## **Service Bulletin**

**Product Type: FastCat & Rocket**

**Bulletin No: JC-017-08**

### **PTO Idler Belt Guide**

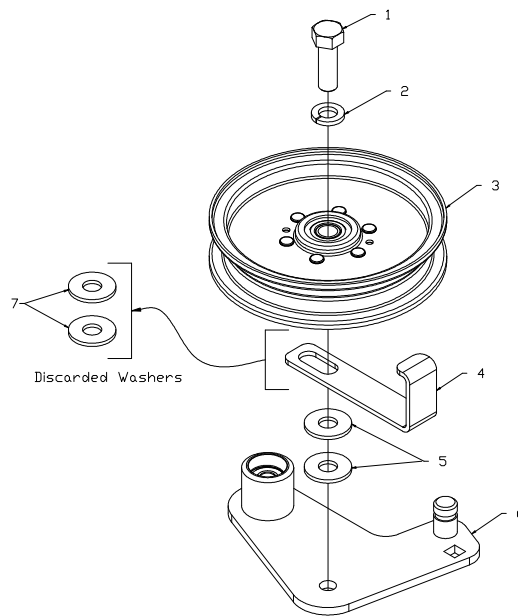
**ISSUE:** We have received reports of the belt jumping off on 48" Fastcat & Rocket units when the cutting height is set very low. To date no reports have been received of this occurring on the 52" units but the idler arrangement is the same. Therefore if it you experience it on a 52" unit, this bulletin would be applicable. This is a rare occurrence that appears to be isolated to southern markets where cutting heights are 2" or less.

**CORRECTION:** Any unit described above that experiences this symptom needs to install belt guide 4163514.7 on the PTO idler pulley. To prevent any possibility of this occurring in the future, we will install this part on all 48' & 52" units manufactured after 7-11-2008.

- 1.) Disassemble idler assembly by removing bolt **1**.
- 2.) Remove and discard (2) washers **7**.
- 3.) Re-assemble idler by replacing discarded washers **7** with belt guide **4**.
- 4.) Position belt guide **4** parallel to rear of cutterdeck as shown in photo.
- 5.) Retighten bolt **1**.
